SIB 61 11 21

SERVICE ACTION: CHARGING FAN DIODE RETROFIT

2021-09-07

Model	Model Description	Model Year
K17	C Evolution	2016 and onward

► **Installing flyback diode for fan**

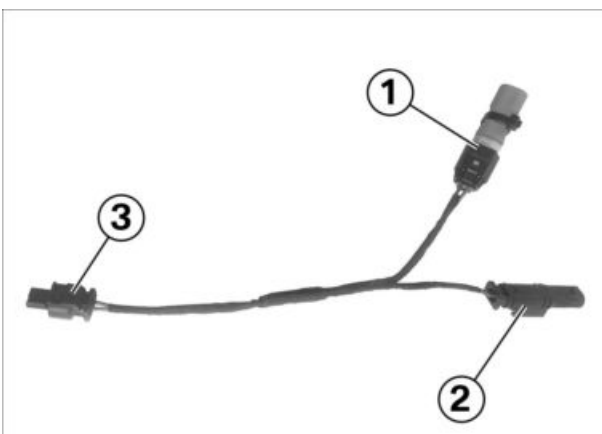
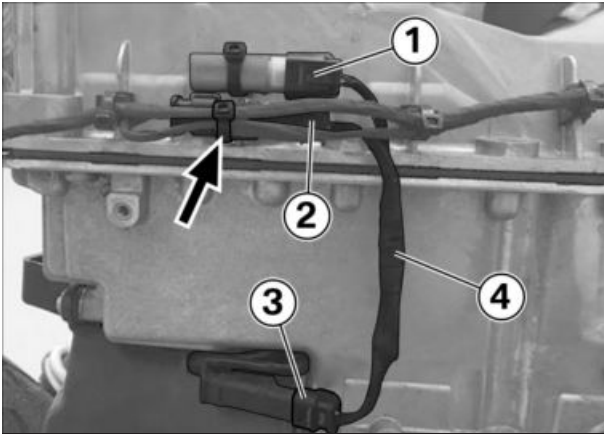
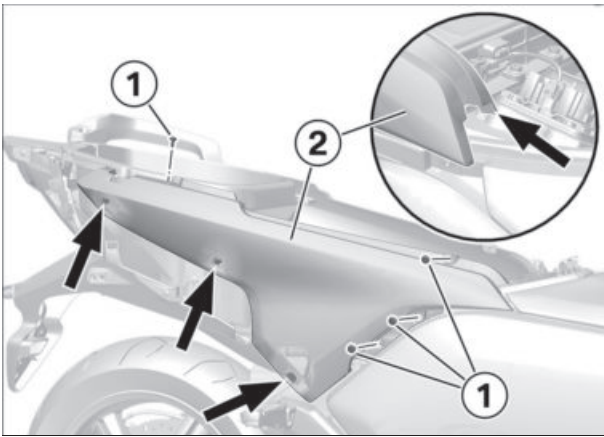
To protect the EME module, affected vehicles need to be retrofitted with a flyback diode for the charging fan.

- Disconnect connector **(1)** for the fan.
- Install cable holder **(2)**.

- Overview of additional wiring harness for flyback diode.

- Connector **(1)** flyback diode.
- Connector **(2)** to wiring harness.
- Connector **(3)** to fan.

- Connect connector (3) with connector for fan
- Connect connector (2) with wiring harness.
- Route additional wiring harness (4).
- Secure flyback diode (1) with cable clip.
- Secure the cable strap (arrow).
